Land East of Southgate Road, Potters Bar WH/3117/2020

i-Transport LPP have submitted a Transport Assessment Scoping (TAS) note (NM/MD/AT/ITL16195-001A) for the proposed redevelopment of the Former Bio-park site in Welwyn Garden City (HCC Ref WH/3117/2020) for circa 300 residential units. The site in central Welwyn Garden City is bound to the south by the Corals Mead allotments, to the east by the relatively recently redeveloped Penn Way residential area, to the north by an existing distribution centre and to the west by the East Coast Main Rail Line. The proposal site is also located immediately to the south west of the ongoing residential led redevelopment of the Wheat Quarter. The Local Planning Authority (LPA) is Welwyn and Hatfield Borough Council (WHBC).

Possible Sustainable Access to Penn Way

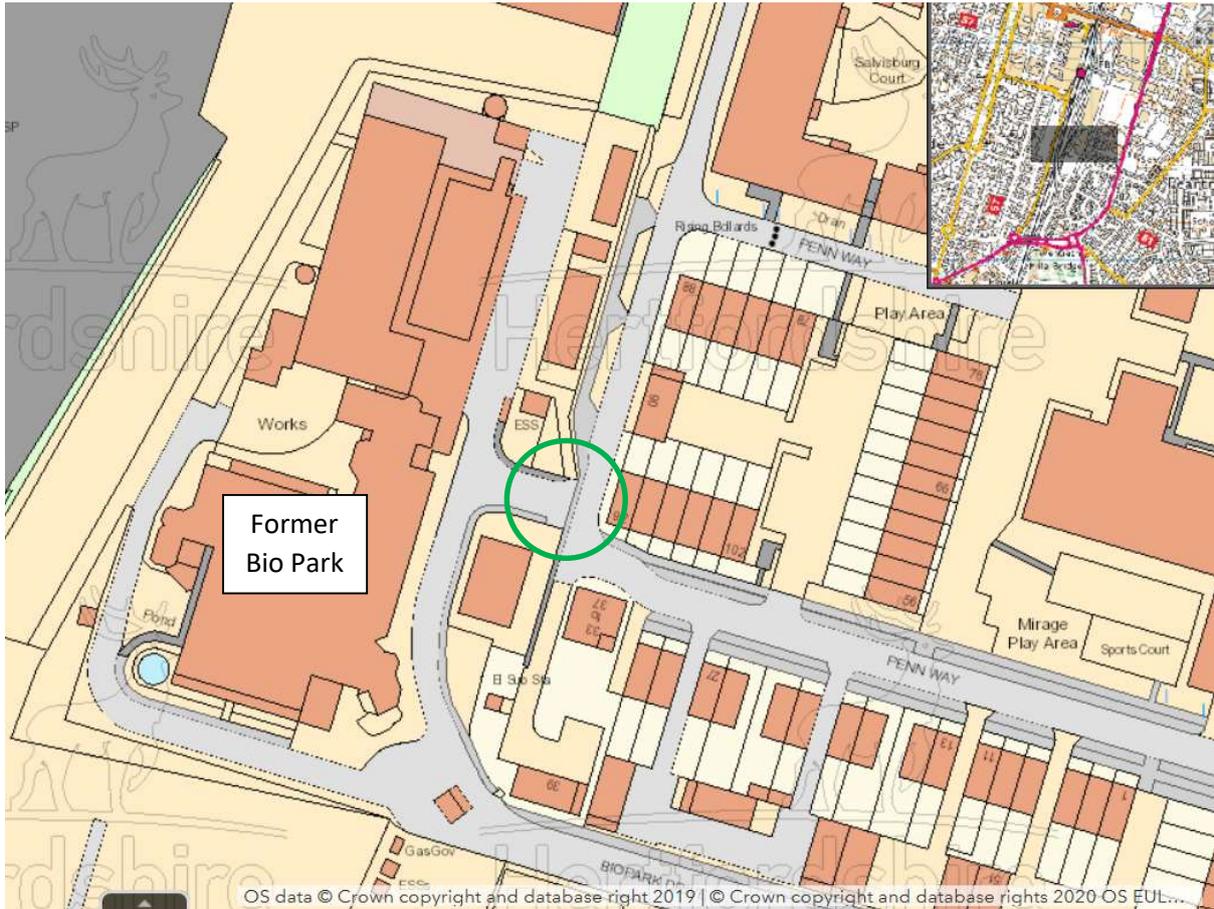
Whilst the original Roads in Hertfordshire (RiG) guidance indicated that, *'There will be a general presumption that not more than 300 dwellings (or equivalent size of development) should be served from a single point of access to the wider road network.'* Given the required length of access road (circa 160m) to serve the proposal site, the increased proposals (300 as oppose to 200 dwellings) and the policies promoted in LTP4 aimed at encouraging active travel and promoting developments that do so, it is considered by HCC Highways that a secondary sustainable/ emergency access, such as the connection to the Wheat Quarter, is essential.

There may also be an opportunity to establish a sustainable connection to Penn Way.
